Planning Services
Kirklees Council
Huddersfield
HD1 9EL

Planning objection – 11 Wood Street 4 no. Residential Dwellings - Planning Application reference 2024/62/91934/E

Figure 6 – Splay being impeded by existing tree (Source ATTP Appendix C HS April 2024)

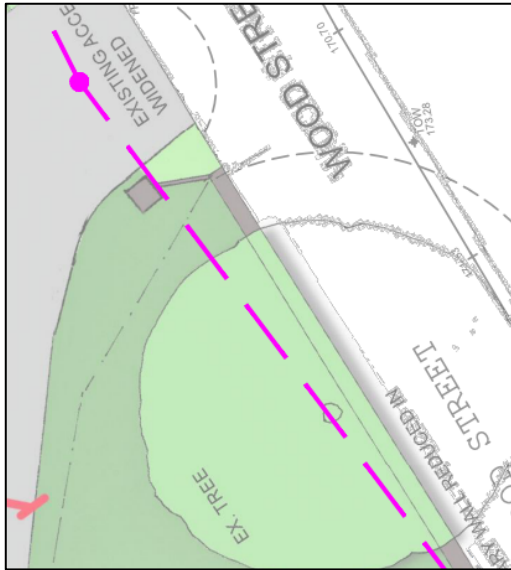
Appendix C contains a visibility splay diagram that shows that the tree trunk immediately adjacent to the access blocking visibility in the critical direction.

The wall is reduced to 900mm in height and MfS states that visibility must be clear between 600mm and 2000mm, the proposed wall height (900mm) would prevent the splay being achieved as submitted, at 900mm small children cannot be seen, this gets worse closer to the access as the level on Wood Street reduces.

Figure 10 – Splay crossing 3rd party land not covered by red or blue boundary included in application (Source ATP Appendix C HS April 2024).

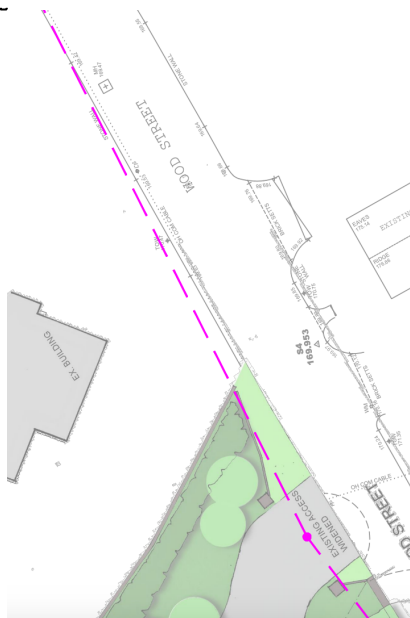
In the non-critical direction, the splay is taken across land outside of the blue and red line provided by the applicant. Based on the submitted information the applicant has no control over this land, at present this area of private garden is contained by a fence in excess of 2m in height, blocking any visibility splay to Wood Street. This land is not contained within either the blue or red line and until it is demonstrated that this is the case the splay cannot be delivered and should not be relied upon to be available or provided now or in the future.

Figure 13 – Telegraph Pole (TP) and Lamp Post (LP) both require relocation to provide the widened access (Source ATTP Appendix C HS April 2024).

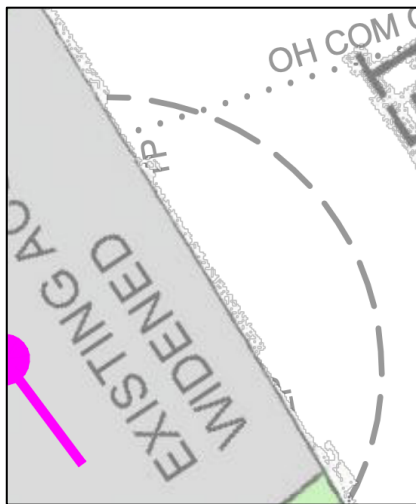
The access is widened to aid pedestrian visibility, this is a positive, however the relocation of the existing Telegraph Pole and Lighting Column will need further consideration as this will add cost/risk which the applicant must commit to now, both items are shown on the topographical survey under the ATTP drawing;
